January 11, 2010

DOCKET	
09-AFC-5	
DATE	<u>JAN 11 2010</u>
RECD.	<u>JAN 11 2010</u>

Re: Abengoa Mojave Solar Project (09-AFC-5): Supplemental Written Response to Data Request Set 1A (nos. 1-93) for Air Quality and Public Health

Process Flow Block Diagram - HTF Venting System
 These numbers are total for two plants Alpha & Beta.

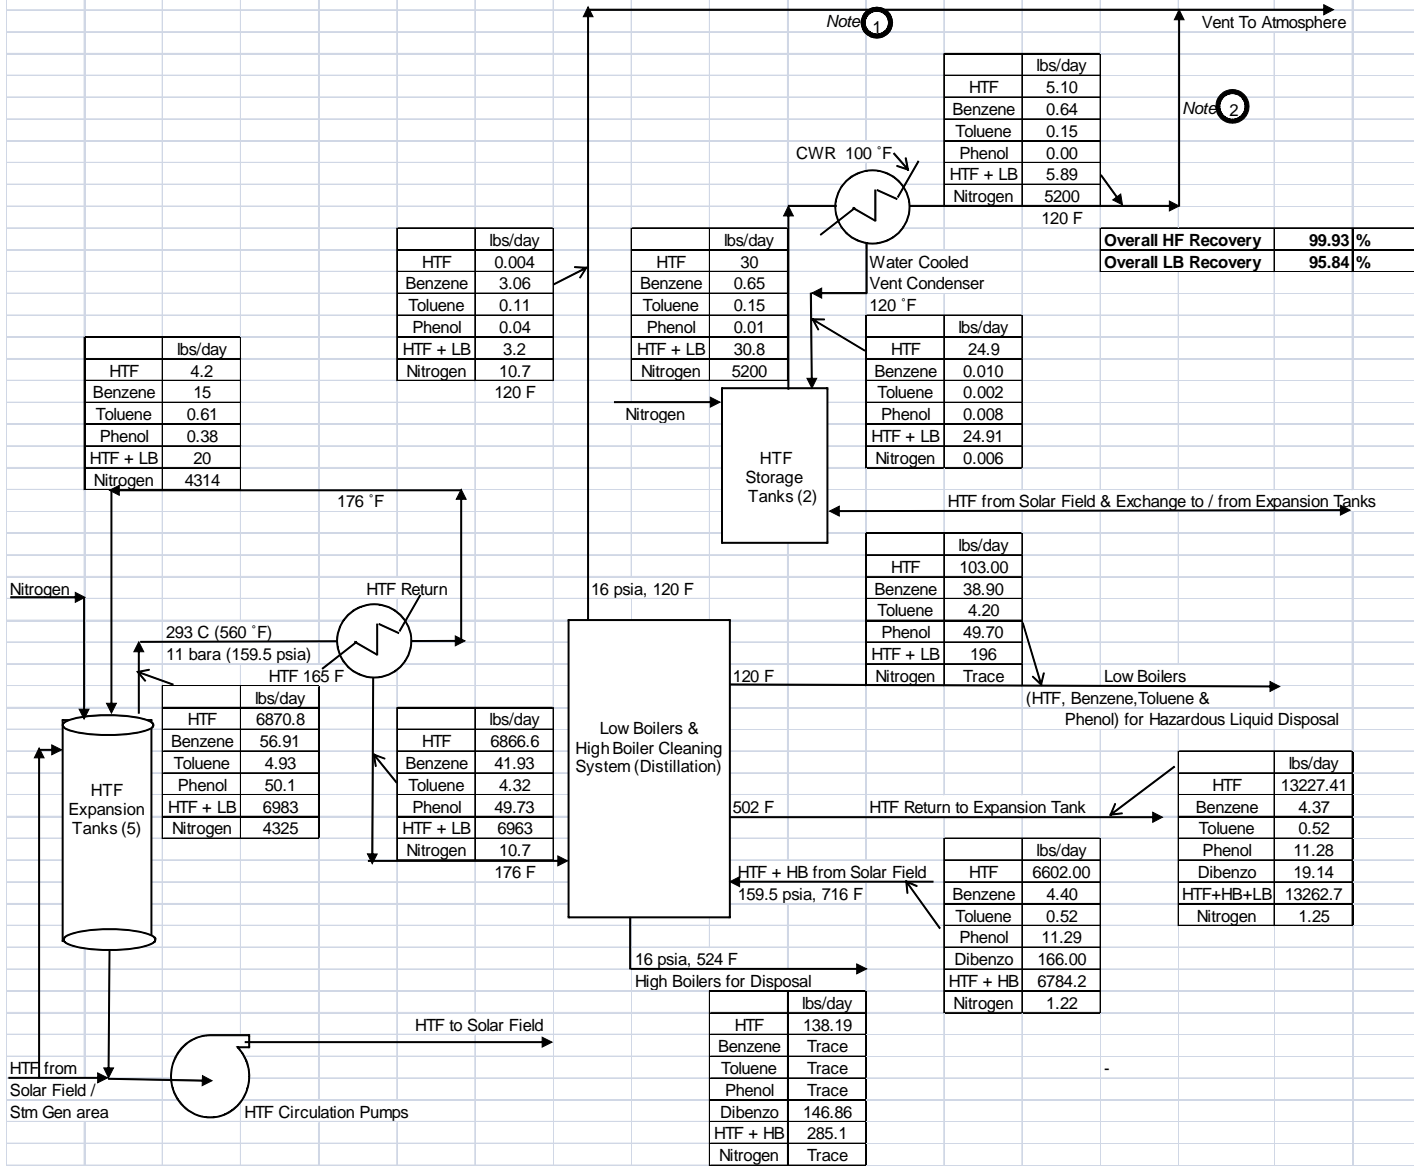
Please identify whether the applicant is willing to stipulate to the incorporation of a carbon adsorption, or other VOC control system, to control VOC emissions from the HTF expansion system venting by at least 98 percent. If unwilling to stipulate to this condition, please identify the basis for this position.

The Applicant proposes the following system for VOC control from the HTF expansion system.

The Mojave project has two identical Alpha and Beta plants. The numbers on the following flow diagram are totals for both plants together. The HTF system of each plant will consist of 5 vertical ASME-rated expansion tanks, one nitrogen-condensing ASME-rated tank (same size as expansion tank) and two vertical HTF storage tanks.

These expansion tanks and the nitrogen condensing tanks will be sized such that during normal operation the expansion/contraction of the HTF will be kept within these tanks and an initial fill of nitrogen will also be kept within tanks by allowing the nitrogen/vapor space pressure to vary from 3 bara to 11 bara nominally. However, after filling all pipes initially at ambient temperature (with high density – lower specific volume), the expansion of the HTF from the ambient temperature to the daily operating temperatures will push the HTF that is not needed in the system during daily operation from the expansion tanks into two storage tanks that will be kept cooler (at about 165 °F) and blanketed with 2-15 inches Water Column (in. WC) nitrogen pressure.

During daytime operation, when the HTF is heated and expands, the expanded volume will move into the expansion tanks and the nitrogen will be compressed and pushed into the nitrogen condensing tank. At night when the HTF cools and contracts, the HTF will move back into the piping and the nitrogen in the vapor space will expand into the expansion tanks.

Although venting would be limited by letting the nitrogen space pressure rise and fall as necessary to keep it contained within the expansion and nitrogen condensing tanks, the LB's which will be released into the vapor space at operating temperature will be removed from nitrogen space by condensing them in the nitrogen condensing tank by cooling them in the tank to about 176 °F.

The storage tanks have coolers on their vent stacks. Nitrogen and HTF mixture to be released passes through the vent coolers, cooled to 120 °F, that will condense most of the HTF vapor vented from the storage tanks before reaching atmosphere. The storage tanks are maintained at 165 °F to minimize HTF venting. The HTF storage tank has a liquid HTF air cooler to maintain this tank's temperature at 165 °F.

As the HTF daily moves into and out of the expansion tanks, the LB's along with some vaporous HTF will be released into the vapor space. To help this separation of LB's into the vapor space, a side stream of HTF will also be sprayed to the top of the expansion tanks continuously. When the expansion tanks fill up with HTF and compress the nitrogen+vapors into the nitrogen condensing

tanks which will be kept cooled to 176 °F, the LB's along with a large amount of HTF vapor will be condensed.

The HTF+LB's condensate will be sent to an HTF LB's and HB's Cleaning System in which the HTF will be recovered as much as achievable with a distillation system. The LB's will be pulled out of the top of the distillation unit and most of the LB's along with some residual HTF will be condensed at about 120 °F (with cooling water) and collected in a tank to be disposed/sold for heat value. The non-condensibles will then be vented through a single point (the same point) as the storage tanks vents.

Low Boilers Removal Scheme: The HTF system is sized to not require nitrogen venting due to HTF expansion. However, to purge low boilers from the system, the expansion tanks will be vented at regular intervals instead of once per year recommended by HTF vendor. The amount of nitrogen vented is the volume of five expansion tanks from 0 to 90% volume. This vented nitrogen at 11 bars (159.5 psia) will include small amounts of HTF and HTF degraded by-products, the LB's. An ASPEN simulation predicted that it is better to condense low boilers under pressure than by expanding the mixture and cooling it (scrubbing through a cooler pool of liquid) in the HTF Storage Tank followed by atmospheric condensation. The expansion tanks' vent stream is cooled to 176 °F at 159.5 psia through a HTF-cooled nitrogen condenser and pressurized condensing tank. The majority of nitrogen is recycled back to the expansion tanks. Condensed HTF along with the low boilers are sent to a HTF Cleaning System.

Release Control Efficiency: Maximum VOC emissions from nitrogen venting are thus 5.1 lb/day HTF with a maximum of 27% or 1.38 lb/day comprised of biphenyl, a hazardous air pollutant (HAP) and 4 lbs/day of benzene, toluene, and phenol. The Title V threshold for hazardous air pollutants is 10 tons/year for any individual HAP. So the HTF and benzene release as calculated is much less than the maximum level allowed. Since the expansion is expected to take place over the course of more than one hour in the morning, the maximum hourly emissions is also the same as daily maximums.

Based on the calculations submitted, this control reduces the potential mass of HTF released from 6867 lbs/day to 5.1 lbs/day resulting in a control efficiency of about 99.9%. Low boilers are reduced from 96 lbs/day to 4 lbs/day resulting in a control efficiency of about 95.8%.
